Amendments to the Drawings:

### REMARKS

This Application has been carefully reviewed in light of the Office Action mailed on August 14, 2008 ("Office Action"). Claims 34-55 are pending in the Application and stand rejected. Claims 1-33 have been cancelled. Claims 36, 43 and 49-55 have been amended.<sup>1</sup> Claim 56 is new. Applicant respectfully requests reconsideration and favorable action in this case.

FIG. 2A

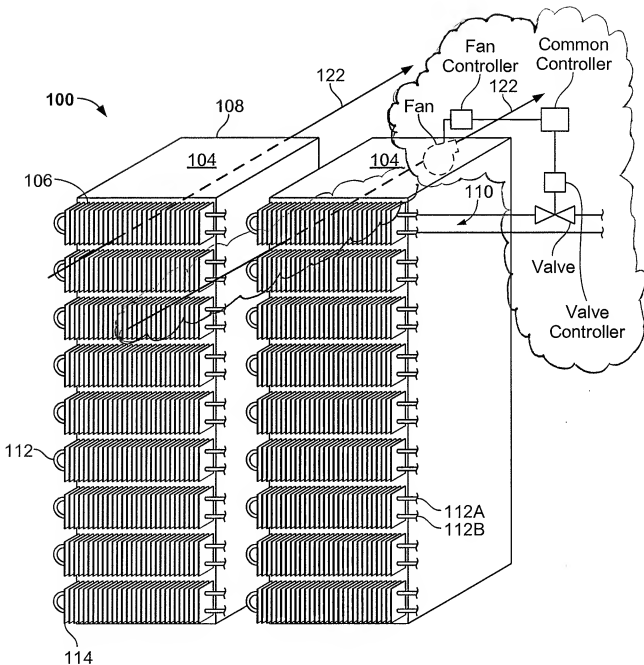
The drawings are objected to under 37 C.F.R. § 1.83(a). The attached replacement sheet of drawings includes changes to FIG. 2A and replaces the original sheet including FIG. 2A. In FIG. 2A, a representative fan has been added to this figure to show an air circulating fan matched to a space between adjacent boards. In addition, FIG. 2A has been amended to show a valve controller operated by a common control system as the fan controller. Applicant respectfully submits that these additions to FIG. 2A add no new matter but merely more accurately illustrate the Application's description of the computing facility 100 and components thereof.

The Office Action objected to the drawings under 37 C.F.R. § 1.83(a) for failing to show every feature of the invention specified in the claims. FIG. 2A has been amended to show an air circulating fan matched to a space between adjacent boards and a valve controller operated by a common control system as the fan controller. Applicant respectfully submits that the foregoing amendments to FIG. 2A do not add new matter but merely more accurately illustrate the description of computer system 100 and the components thereof.
